PRODUCT ADVISORY

Data Sheet Specification Update for Intersil Product ISL54103*

**Refer to:
PA11111**

Product affected: **ISL54103IHZ ISL54103IHZ-T7 ISL54103IHZ-T7A**

Old **POD MO-193 – PA11111**

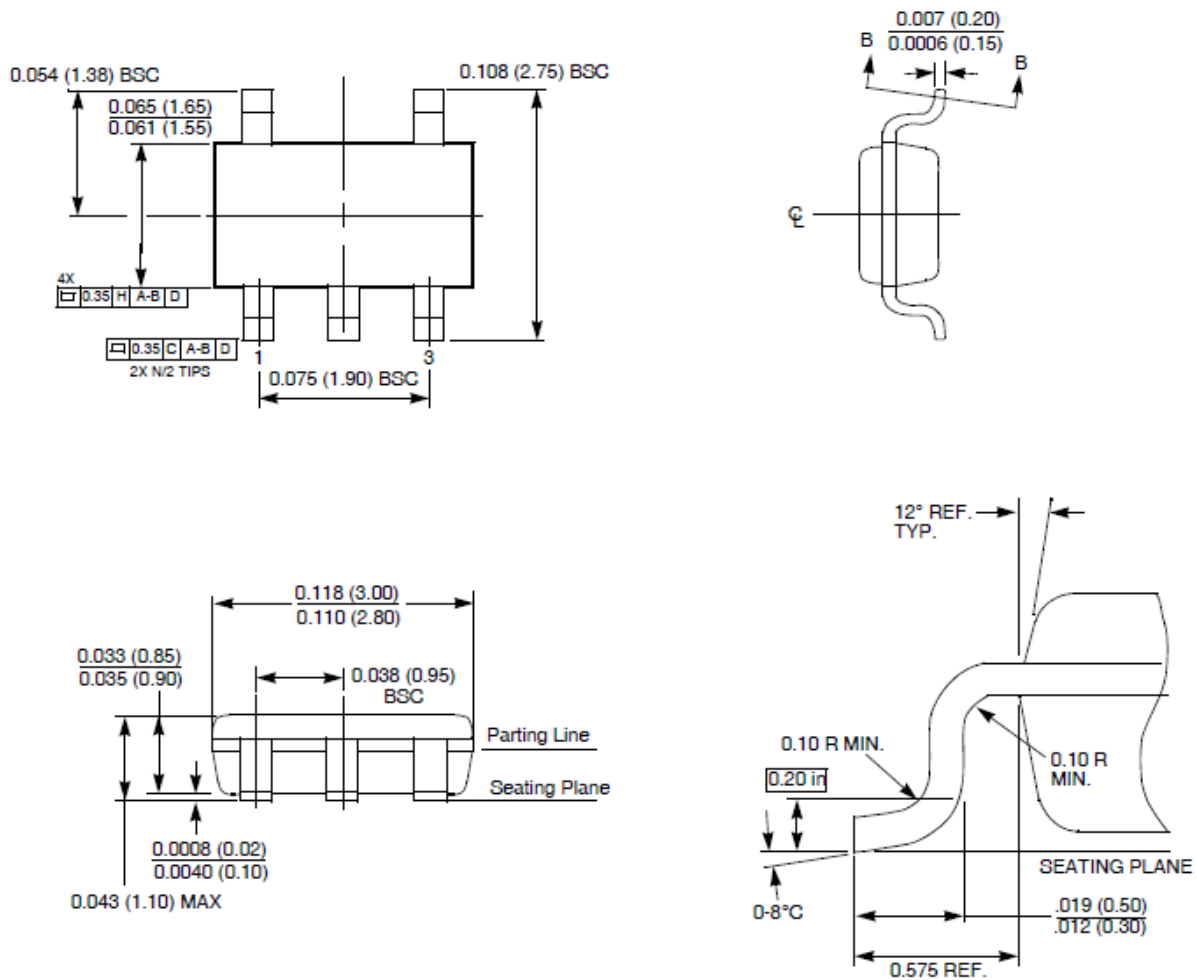
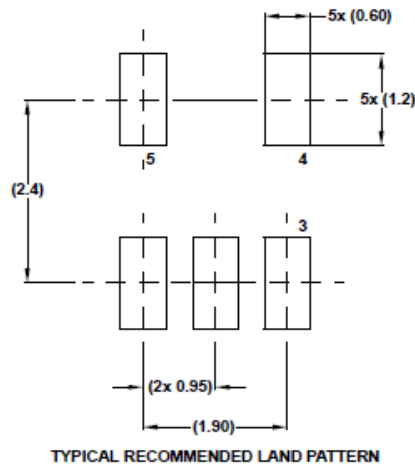
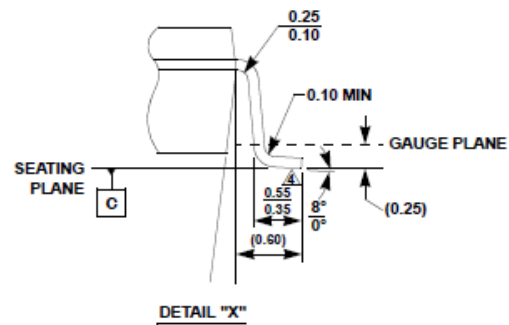
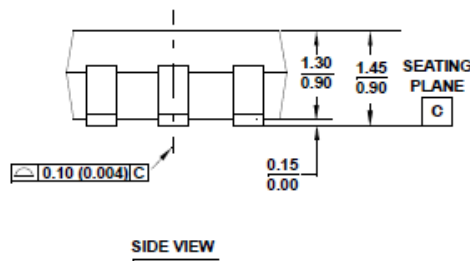
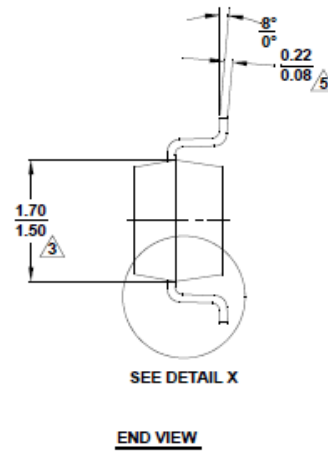
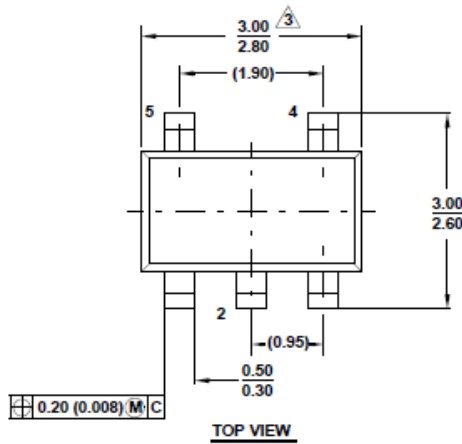
This advisory is to inform you that Intersil has updated the POD (Package Outline Drawing) referenced in the data sheet specification for the listed Intersil ISL54103* products. The POD has been changed to reflect JEDEC outline MO-178AA instead of JEDEC outline MO-193. The old and new PODs are contained on following pages. There have been no changes to the package or product itself. The updated data sheet is available on the Intersil web site at <http://www.intersil.com/data/fn/fn6303.pdf>.
